**NSLPP MEETING HELD ON 01/06/2022****Attachments:**

ADDRESS/WARD: 352 Miller Street, Cammeray**APPLICATION No:** DA 220/21**PROPOSAL:** Demolition of an existing detached dwelling house and construction of a four (4) storey residential flat building containing six (6) units, basement car park and associated landscape works.**PLANS REF:**

OWNER: Link Investments P/L**APPLICANT:** SJR Consulting Australia**AUTHOR:** Robin Tse, Senior Assessment Officer**DATE OF REPORT:** 24 May 2022**DATE LODGED:** 16 July 2021**RECOMMENDATION:** (Deferred Commencement Approval)

Figure 12: Structural Root Zone for Tree T4 and Proposed basement car park

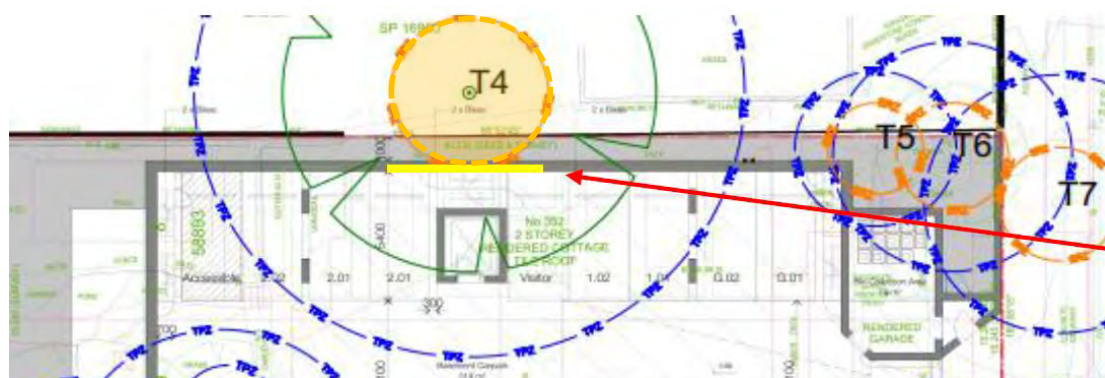
With regard to the impacts on the root system of Tree T4, the structural root zone (SRZ) of the tree is likely to be encroached by the northern wall of the proposed basement as indicated in **Figure 12** below:

The northern wall of the proposed basement car park would provide a 1m setback from the northern property boundary and is likely to have an adverse impact on the SRZ of Tree T4. As indicated in Council's Landscape Officer comments, it is recommended that a deferred commencement condition be imposed requiring the setback for the section of the northern wall immediately adjacent to the SRZ of Tree T4 be increased to 2m in order to minimise any adverse impacts on the SRZ of this tree (**Condition AA1**).

It is recommended that a deferred commencement condition be imposed requiring an additional set back of the basement wall from the structural root zone of an established brush box tree located on the adjoining property to ensure the protection of the established tree.

Figure 20: Sun View Diagrams

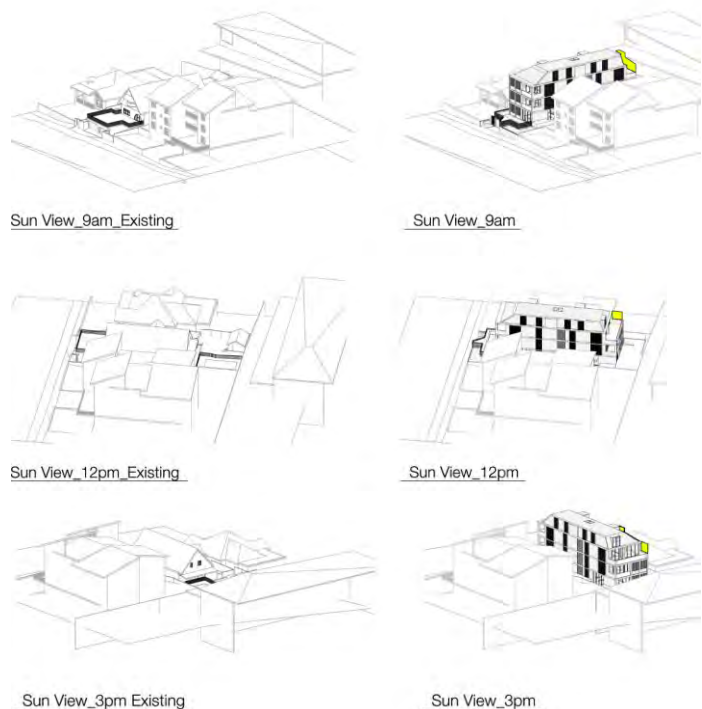
There would be some additional shadowing for about one hour on the northern bay window on the eastern elevation of No. 350 Miller Street from 9.30am onwards. Solar access to the front verandah on the southern side of the adjoining dwelling would be maintained until approximately 10.30am.

The applicant has amended the original proposal by increasing the rear building setbacks on Levels 2 and 3. This would maintain the required three (3) hour solar access to the majority of the rear yard between 11.30am and 2.30pm during mid winter.

1 Basement
1 : 100@A1

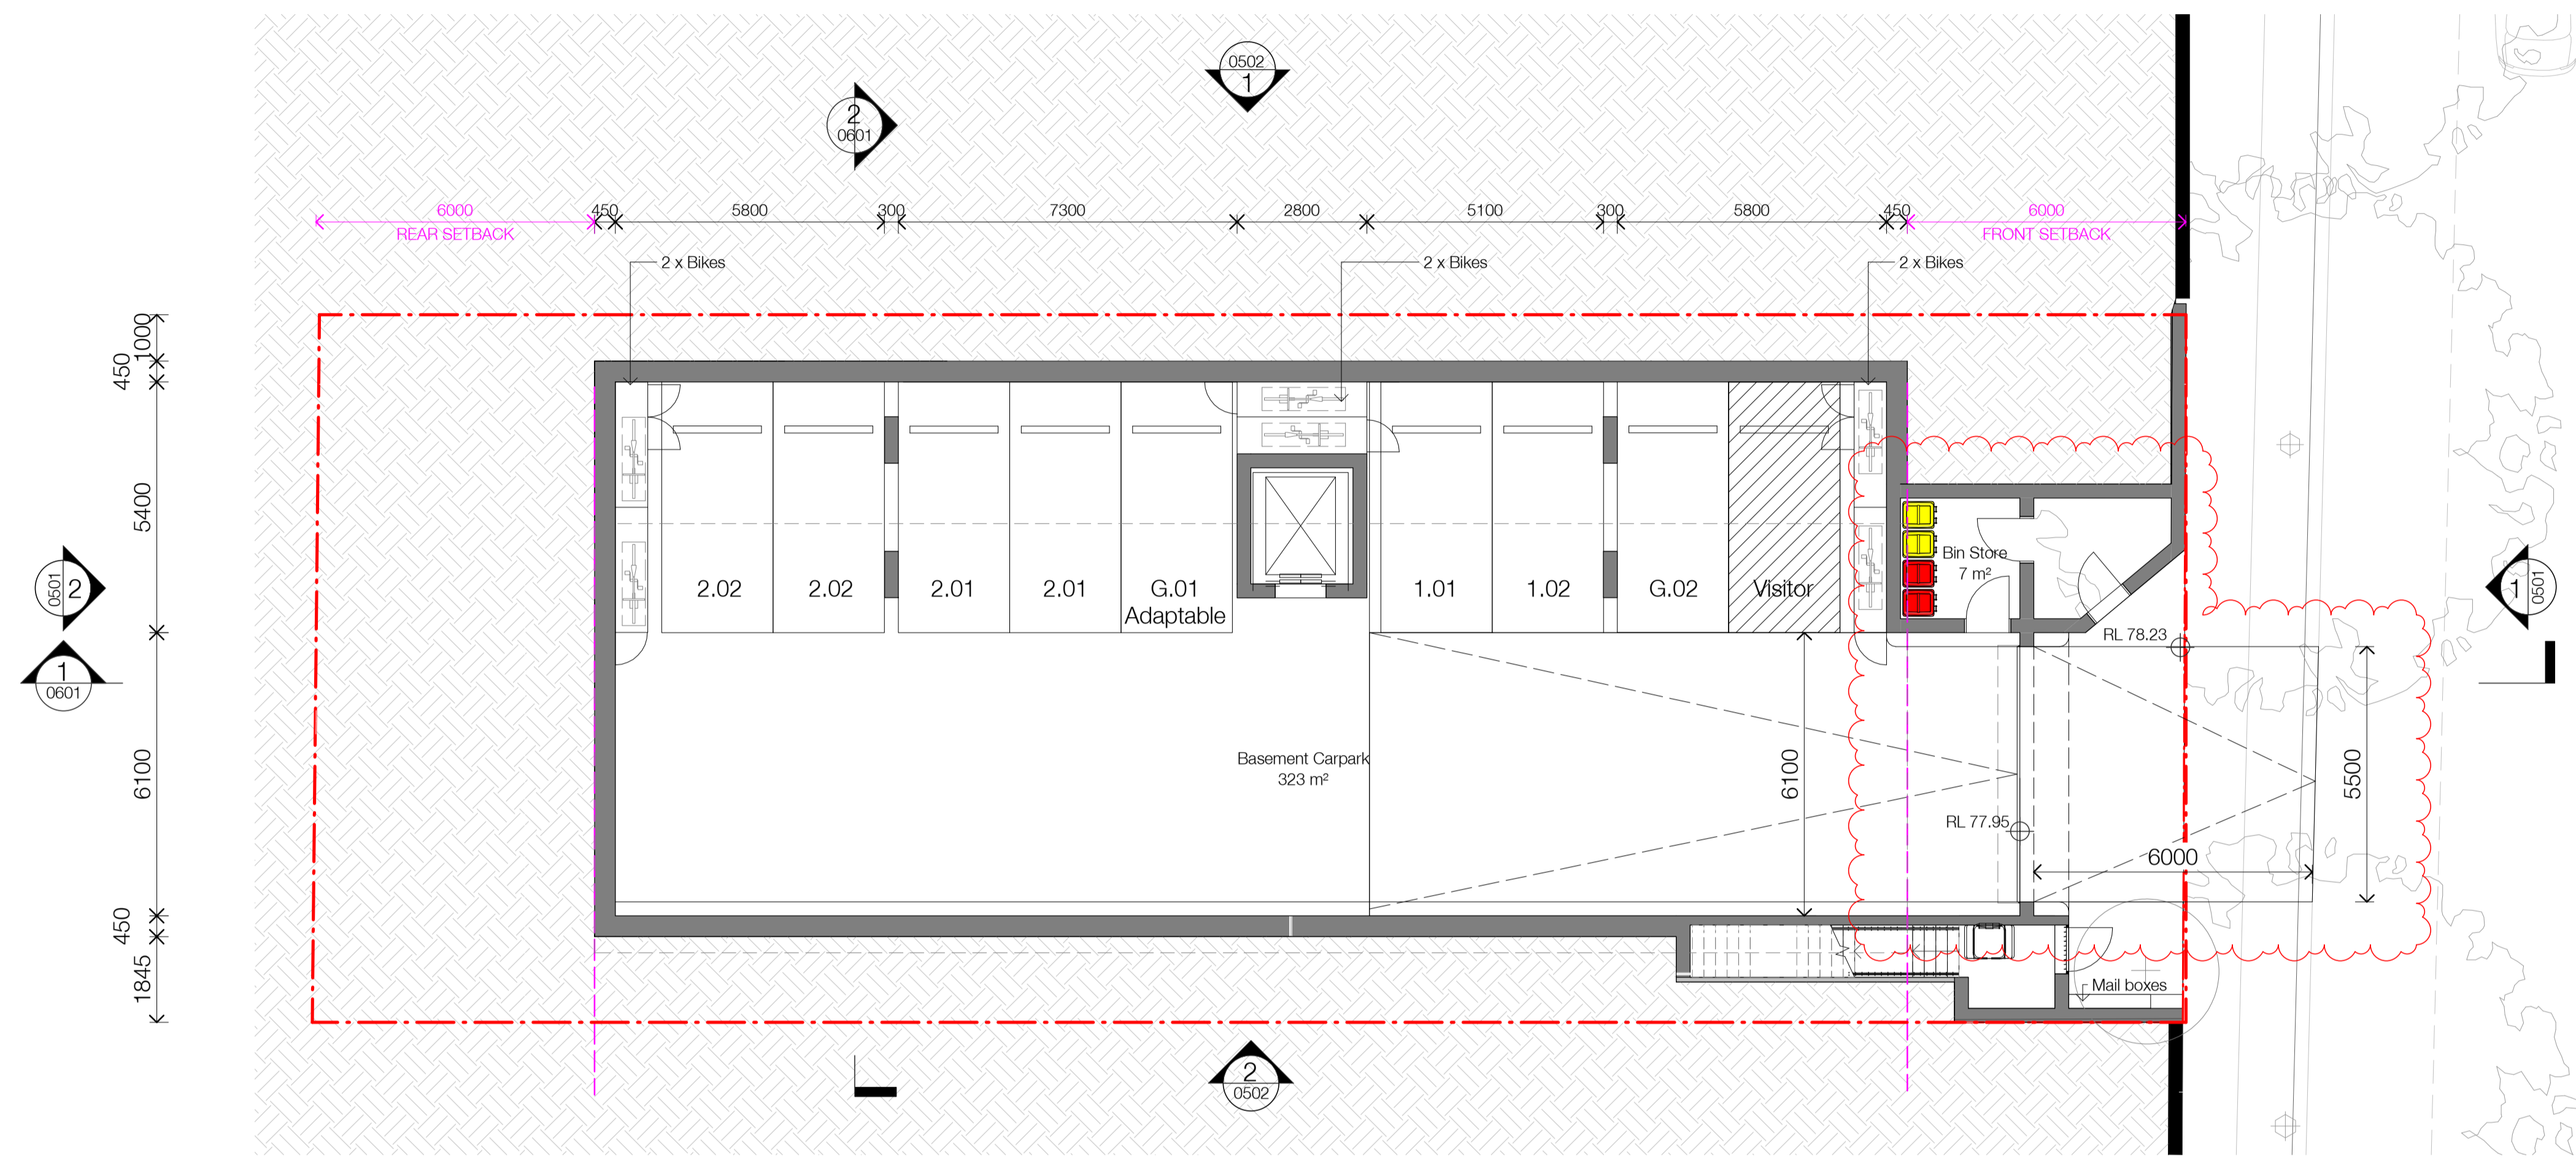
- *Side setbacks:*
 - a) *Northern boundary 3m setback is acceptable, however, the basement extends into the 3m setback impacting on deep soil and possibly the large existing tree on the adjoining property. Delivery of substantial landscaping treatment is questionable;*

- *The potential development impact on the large tree located at No. 360 Miller Street is of concern. Consideration should be given to moving the basement south to minimize soil disturbance adjacent to the large existing trees to the north.*
- *Provision of larger endemic tree planting to rear of the property is encouraged.*
- *Tree removal to the south-eastern corner and Miller Street frontage is unjustified.*
- *The proponent should reconfigure the bin store such to allow new substantial endemic planting to the front of the property.*

Therefore, the applicant's responses are considered to be generally satisfactory subject to the imposition of appropriate conditions including the deferred commencement condition **AA1** requiring design modifications to the basement level to ensure the protection of the brush box tree that is located on the adjoining property to the north of the subject site.
